Generic Environmental Impact Statement for License Renewal of Nuclear Plants

Supplement 2

**Regarding the
Oconee Nuclear Station**

Final Report

Figure 2-4. Oconee Nuclear Station Layout

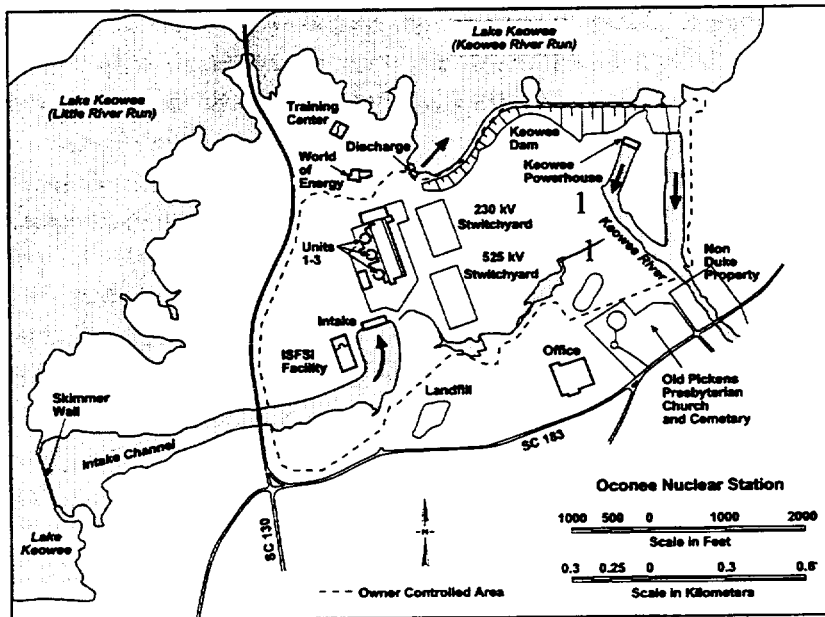
10.	2-6	Figure 2-4	Figure 2-4 appears to list the ONS 525 kV switchyard as the "825 kv Switchyard." Also the standard abbreviation for kilovolt is kV, not kv, as is used in this figure.	Corrected

Figure 2-7. Oconee Nuclear Station - Water Flow Diagram

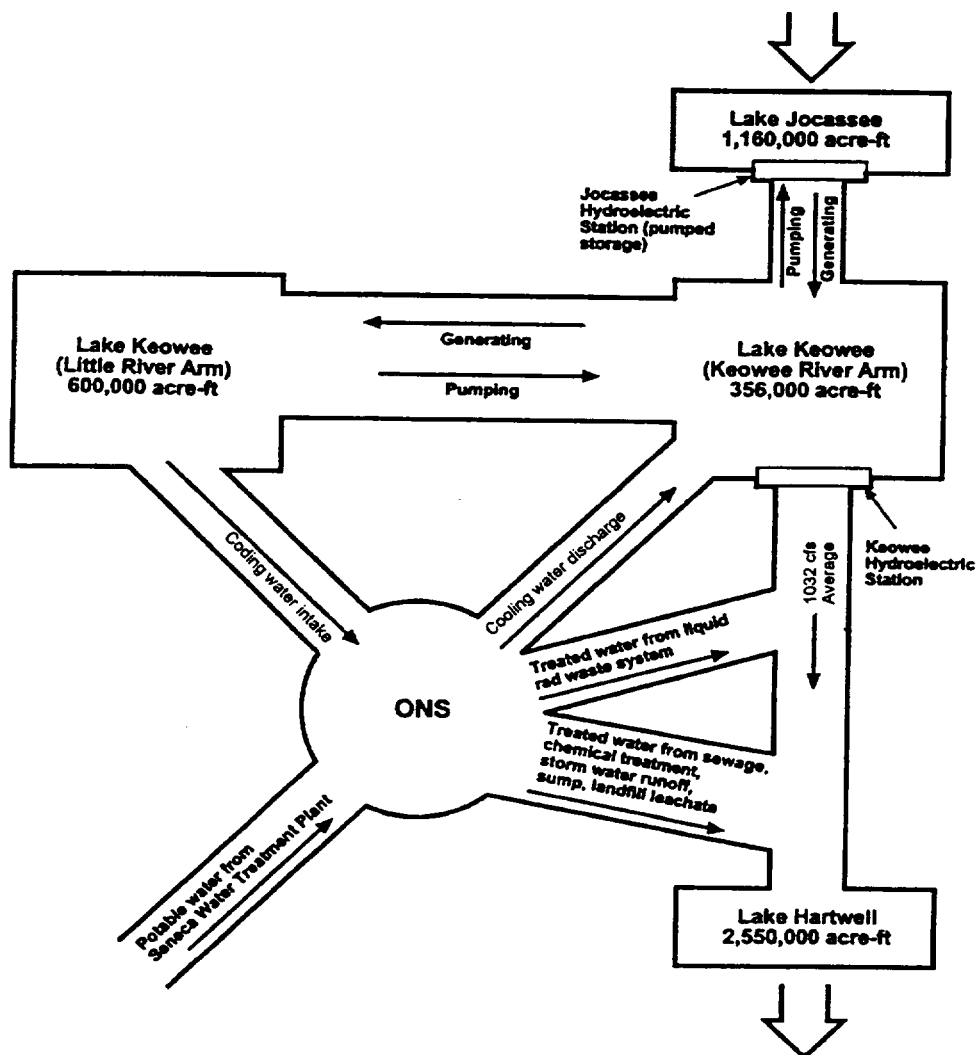
26.	2-15	35	The amount of water supplied from the Seneca water treatment plant and used for potable water is 120 m ³ /d [0.03 million gpd].	Corrected
27.	2-16	Figure 2-7	Revise line to state: "...treatment plant (120 m ³ /d [0.3 million gpd]) is used for potable water." The average flow through Keowee Hydroelectric Station is listed as 1632 cfs. The correct value is 1032 cfs.	Corrected
